### PRODUCT/PROCESS CHANGE NOTICE (PCN)

PCN #: **TP1901-01** Date: February 8, 2019

**PCN Type:** Datasheet Correction

**Figure 3. I<sup>2</sup>C Slave Read and Write Cycle Sequencing**

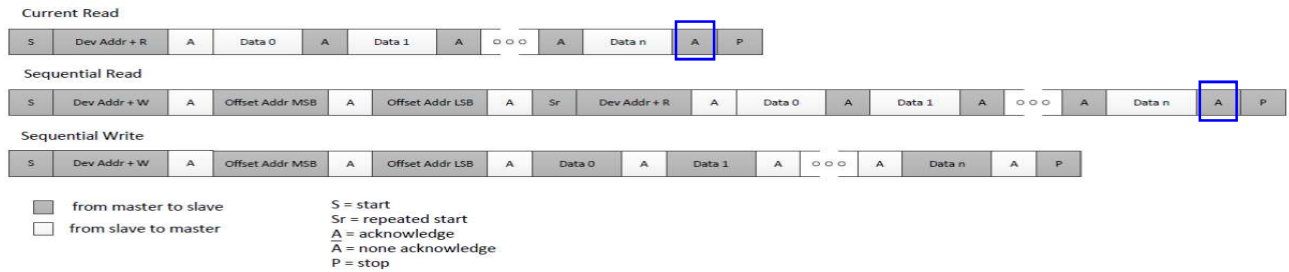
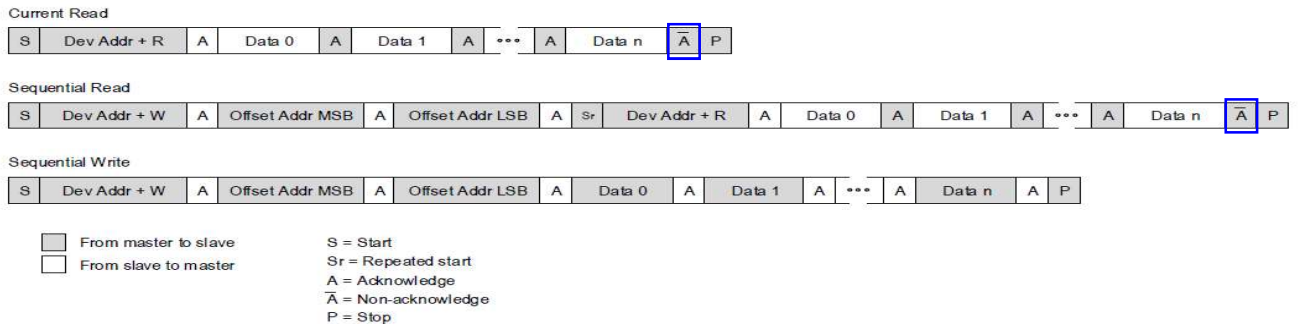
**Detail of Change:** Corrected the I<sup>2</sup>C read sequence diagrams to match I<sup>2</sup>C specification and actual device performance. Below is an example of the change. The figure # reference may vary per datasheet.
